MINUTES OF THE REGULAR MEETING OF THE PLAN COMMISSION, VILLAGE OF TINLEY PARK, COOK AND WILL COUNTIES, ILLINOIS

November 17, 2022

ITEM #1 PUBLIC HEARING – BRADY GILL FUNERAL HOME ADDITION, 16600 OAK PARK AVENUE – SPECIAL USE FOR A DWELLING ABOVE A PRINCIPAL USE AND SITE PLAN/ARCHITECTURAL APPROVAL

**ITEM #2 PUBLIC HEARING – ODYSSEY CLUB TOWNHOMES MODEL
CHANGE – SPECIAL USE FOR PUD SUBSTANTIAL DEVIATION AND
SITE PLAN/ARCHITECTURAL APPROVAL**

Proposed Architectural Site Plan (Updated – Driveway Corner Cut)

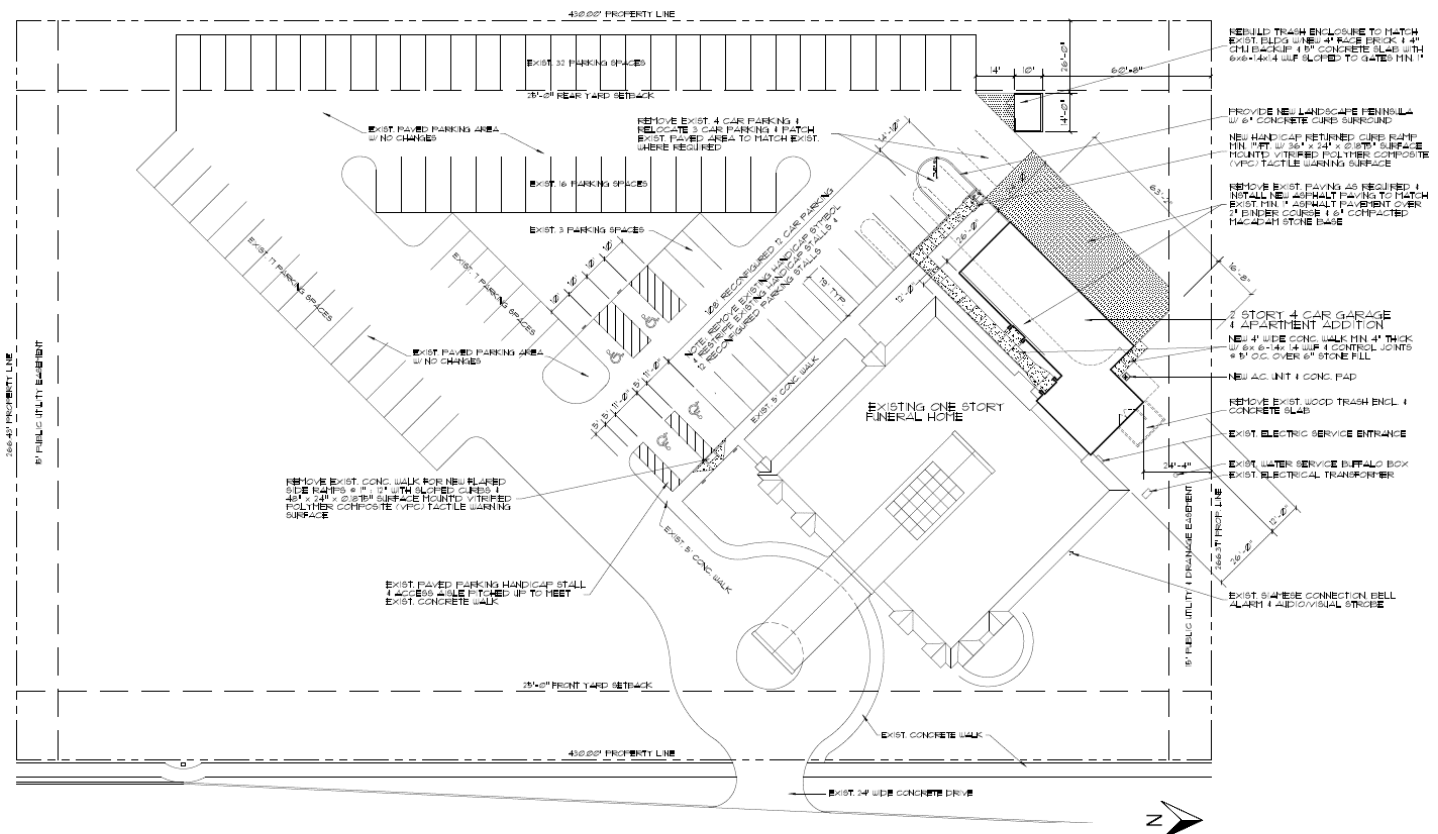
There will be a new ground mechanical unit located in the northern niche space between the back of the storage room and side of the garage. With the proposed site improvements, there will be some lawn remaining to the northwest corner of the site. **The architectural plans have been updated to coordinate with the preliminary engineering plans, depicting a small corner cut of the driveway access so that it won't be in the public utility and drainage easement.**

Plan Commission Workshop feedback was in support of the proposed site improvements, addition, driveway, landscape peninsula, and trash enclosure.

Proposed Landscape Plan (Updated – Driveway Corner Cut)

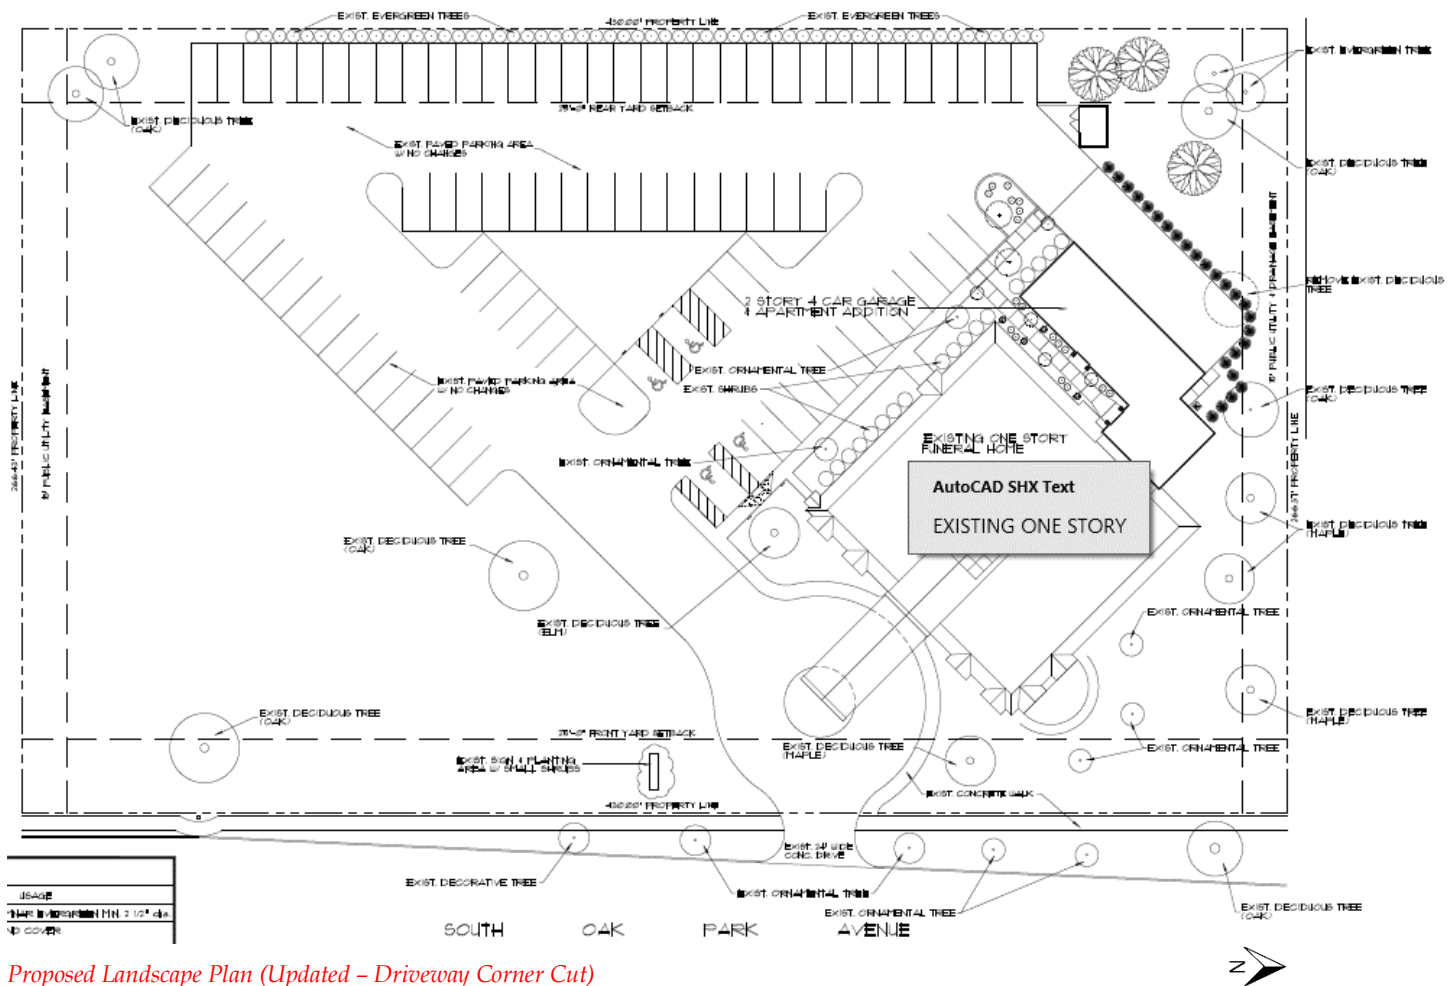
The new curbed, landscaped peninsula was requested by Village Staff to help address the Village's Landscape Code requirements and guide vehicles through the lot. Staff is not supportive of a waiver to exclude it. The Landscape Code requires that parking lot islands (peninsulas) shall be located at the end of each row of parking stalls or as otherwise approved in the landscaping plan. The code further states each island shall be at least 200 sq. ft. and at least 10 feet wide, and include at least one tree and one shrub per 200 sq. ft. of island green area. Currently, aside from the triangular lawn in the center of the parking lot with trees (shown on engineer's Existing Conditions plan), there are no existing landscaped islands/peninsulas on the site. **Prior to the Plan Commission workshop, the Petitioner's architect stated they were not supportive of these areas as they felt over landscaped peninsulas and/or islands can be hazardous to not only traffic flow but to unseen pedestrians.** They noted its magnolia tree is a small, ornamental tree, and the ground cover bushes do not exceed 24" in height. Staff is supportive of the proposed peninsula as they are important to the overall design and traffic flow of parking lots. Any visibility concerns can be resolved by adjusting to different plantings and general landscape maintenance. **At the Plan Commission Workshop, there was no objection raised to the landscape peninsula. The Commission expressed agreement with code requirements for the peninsula, and that it will help alleviate traffic concerns. The Petitioner's architect noted the smaller tree and bushes were proposed to help not obstruct viewpoints. The preliminary engineering plans were slightly modified to depict the correct width (14'-10" face to face) of the proposed peninsula in coordination with the architect's drawings.**

Proposed Lighting Plan (Updated - Driveway Corner Cut)

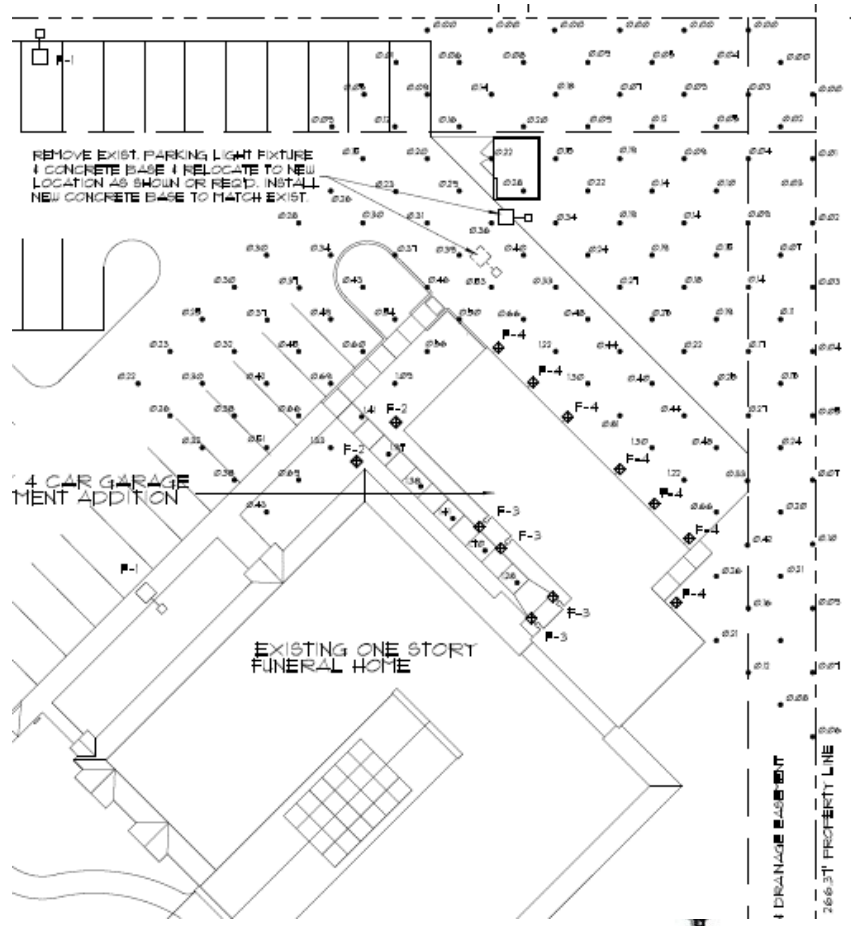
The architect's plans indicate 0.10-foot candles at the property line abutting nonresidential (north) and zero foot candles abutting residential (west), which meets the Zoning Ordinance's maximum requirements. The code regulates that property line foot candles adjacent to nonresidential properties be maximum 2.0-foot candles, and maximum 0.10 foot candles to residential.

There were no objections raised to the proposed lighting at the Plan Commission Workshop.

General Site Plan – Highlights Proposed 25 buildings & unit counts (Tech Metra Ltd.)

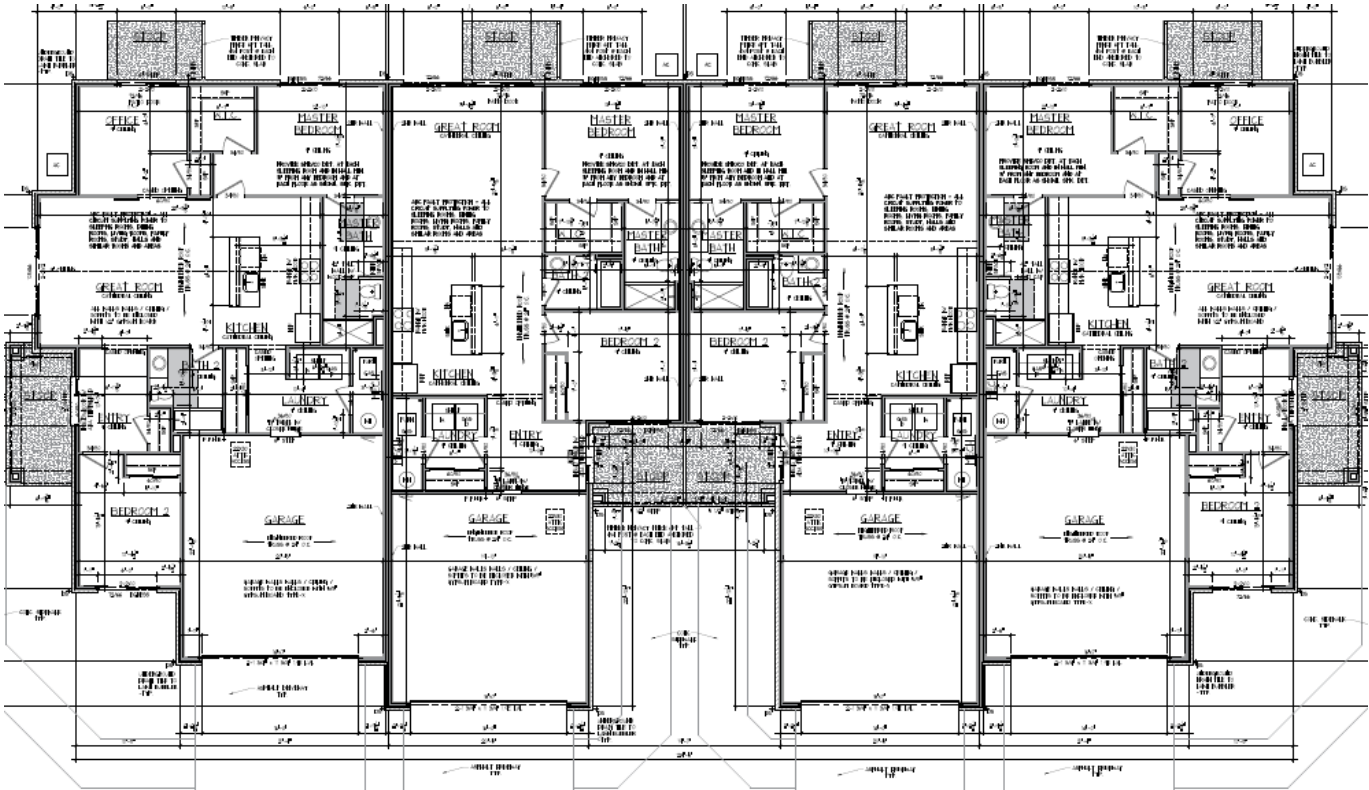
Open Item #1: Discuss whether the proposed change to single-story ranch is appropriate for the Planned Unit Development.

The Petitioner has provided site plan drawings. One plan (shown above) generally highlights the proposed building outlines with unit counts, with existing buildings shown as light outlines (Tech Metra Ltd.) The second, more detailed plan (shown below) also shows building setbacks, grading, utilities, and easements, along with existing building footprints (Civil Environmental Consultants, Inc.) The proposal slightly reduces the building footprint (lot coverage) of the 25 buildings from the previous approval. The Petitioner has provided a spreadsheet exhibit which notes these reductions as 325 sq. ft. in four-unit type, 593 sq. ft. in the two-unit type, and 627 sq. ft. in the three-unit type.

Elevation Comparison – Proposed (New Style) vs. Existing/Previously Approved (Old Style) – 4-Unit Type

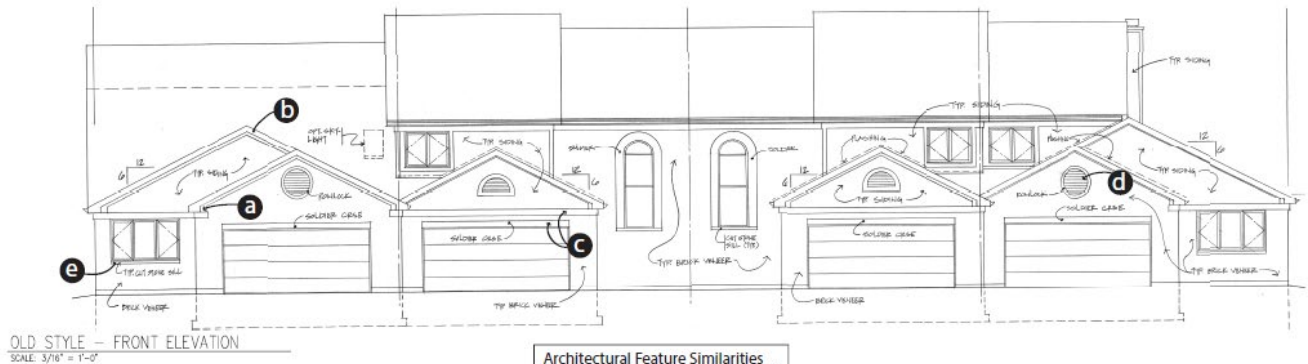
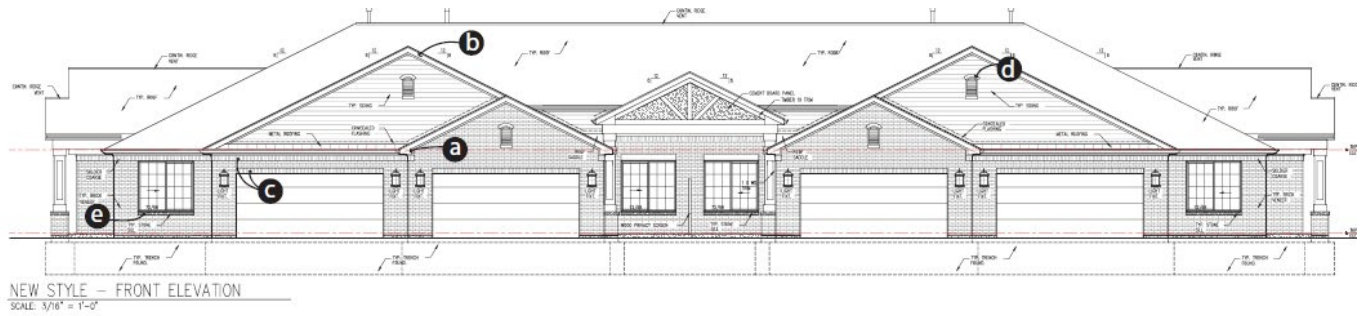
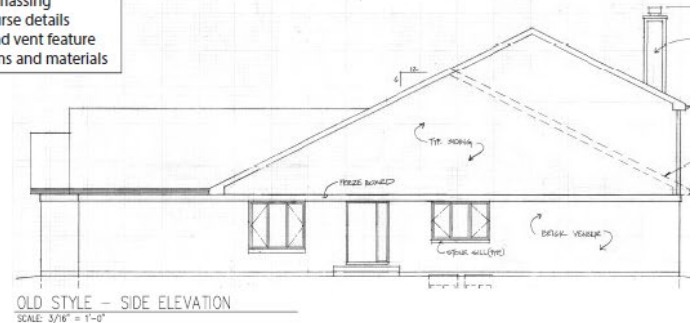
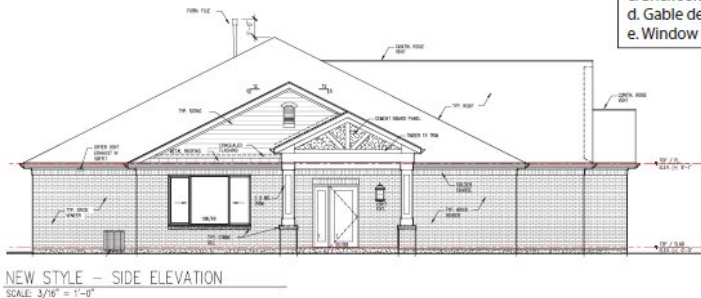
COMMISSIONER SHAW noted that the Petitioner is correct. It is only on the 4-unit buildings that the excessive shingling is an issue.

COMMISSIONER GATTO noted that she feels there could be some modification to the 4-unit building.

COMMISSIONER MANI noted that if you put gable on some of the properties it will make it an atypical unit suggesting that if it will be added it will need to be added to be consistent.

Anthony DeAngelis responded that he and his team feel that the proposed front elevations are an improvement from the existing citing that was an explicit intention when preparing the plans. He continues by stating that they are not opposed to looking into remedying the rear elevations on the 4-unit buildings.
